Access Compliance Report

Public Rights-of-Way

Intersection ID: N/A	Main Street: WEDDINGTON_RD	Cross Street: N/A	Location: NW
ADA ID: 4DB2610D4579	Ramp Type: PerpDiag	Initial Pass/Fail: Fail	Overall Compliance: No
		Severity Score: 25

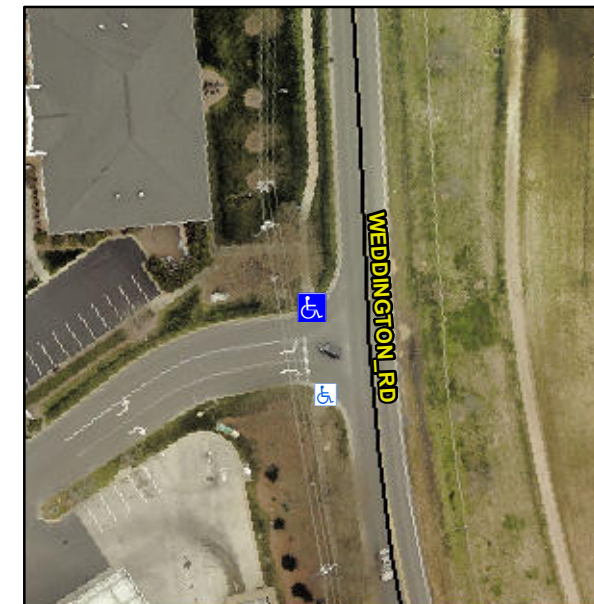
Not Found, R304.5.3

Compliance	Description	Data	Compliance	Description	Data
N/A	Ramp Length (in)	60.0	Yes	Ramp Slope (%)	7.6
Yes	Ramp Width (in)	48.0	No	Ramp XSlope (%)	10.1
N/A	Flare Type LT	N/A	N/A	Flare Type RT	N/A
N/A	Flare Slope LT (%)	N/A	N/A	Flare Slope RT (%)	N/A
N/A	Flare Traversable LT?	N/A	N/A	Flare Traversable RT?	N/A
N/A	Landing Length (in)	N/A	N/A	DWS Provided?	N/A
N/A	Landing Width (in)	N/A	N/A	DWS Contrast?	N/A
N/A	Landing Slope (%)	N/A	N/A	DWS Length (in)	N/A
N/A	Landing X Slope (%)	N/A	N/A	DWS Full Width?	N/A
N/A	Landing Curb? (Y/N)	N/A	N/A	DWS Offset (in)	N/A
N/A	Shared Landing?	N/A			
N/A	Gutter Ponding?	N/A	N/A	Gutter Slope (%)	N/A
N/A	Gutter Lip Ht (in)	N/A	N/A	Gutter X Slope (%)	N/A
N/A	Painted X Walk1?	No	N/A	Painted X Walk2?	No
	X Walk 1 Direction	To S		X Walk 2 Direction	To E
N/A	X Walk 1 Width (in)	N/A	N/A	X Walk 2 Width (in)	N/A
	X Walk 1 Slope (%)	3.3		X Walk 2 Slope (%)	1.2
	X Walk 1 X Slope (%)	0.9		X Walk 2 X Slope (%)	1.4

Remove & Replace Curb Ramp With Two New Directional Ramps or Equivalent.
